### USB 3.0 Errata (last updated 5/1/2011)

Figure 7-13. State Diagram of the Link Training and Status State Machine

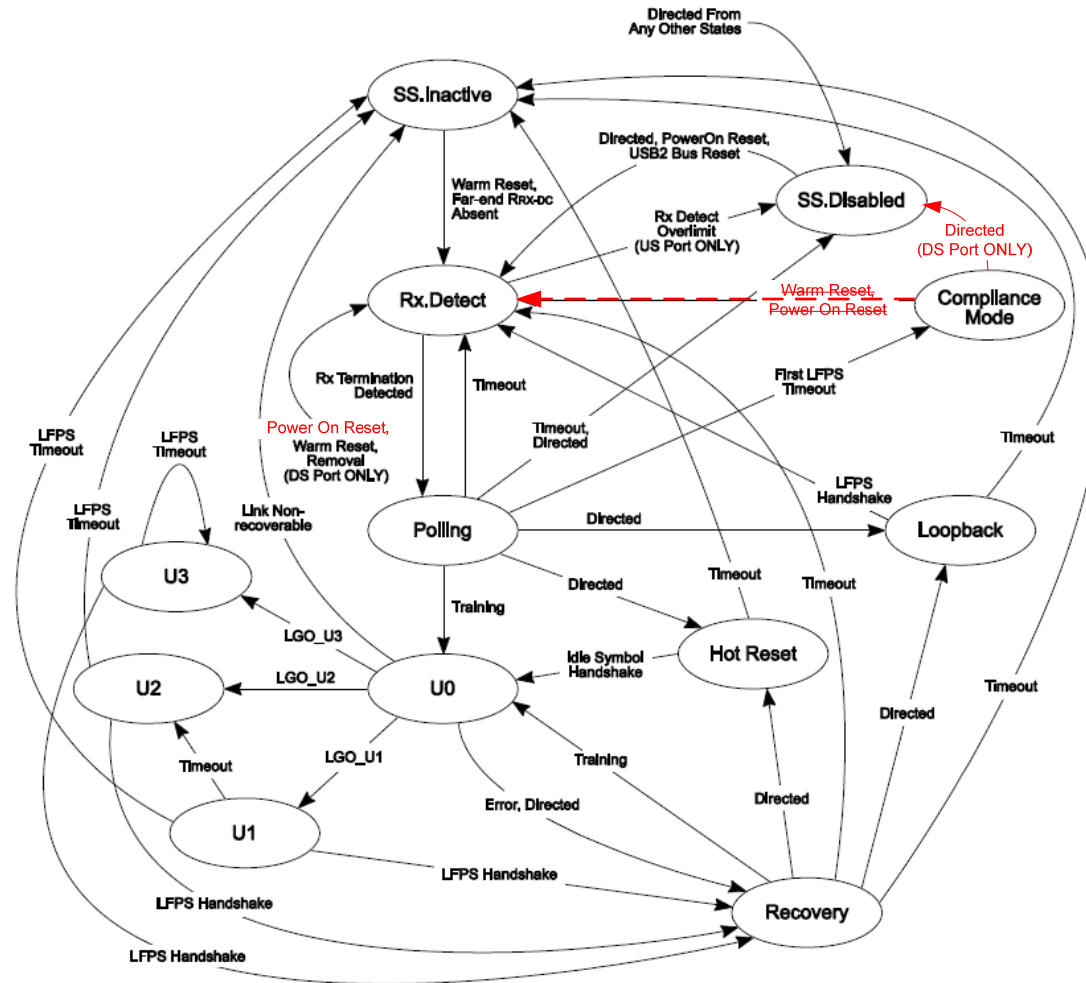
The LTSSM State Machine in Figure 7-13 defines a “Warm Reset, Power On Reset” transition between **Compliance Mode** and **Rx.Detect**. But section 7.5.5.2 of the USB3 spec “Exit from Compliance Mode” says that the Compliance Mode state is exited by a downstream port **only** if it is directed by software to do a Warm Reset or to disable the port. Nowhere in the section is “Power On Reset” mentioned, and the Compliance Mode to SS.Disabled transition is not shown in Fig 7-13.

Also, per section 7.5.3, it doesn’t matter what state you are in, a “Power On Reset” will always transition a port to the Rx.Detect state.

- 1) The first sentence in section 7.5.3 says, “Rx.Detect is the power on state of the LTSSM for both a downstream port and an upstream port” so the “Power On Reset” condition should be added to the global “Warm Reset, Removal (DS Port ONLY)” transition into Rx.Detect in Fig 7-13 making it consistent with the section 7.5.3 text.
- 2) The Compliance Mode to Rx.Detect transition can be dropped because it is covered by the “Power On Reset” and “Warm Reset” conditions, of the global transition into Rx.Detect.
- 3) And a Compliance Mode to SS.Disabled “Directed (DS Port ONLY)” transition should be added, to make Fig 7-13 consistent with the text in section 7.5.5.2.

<sup>i</sup> Need to remove the arc from Compliance mode to SS.Disabled.

See the updated Figure 7-13 below.
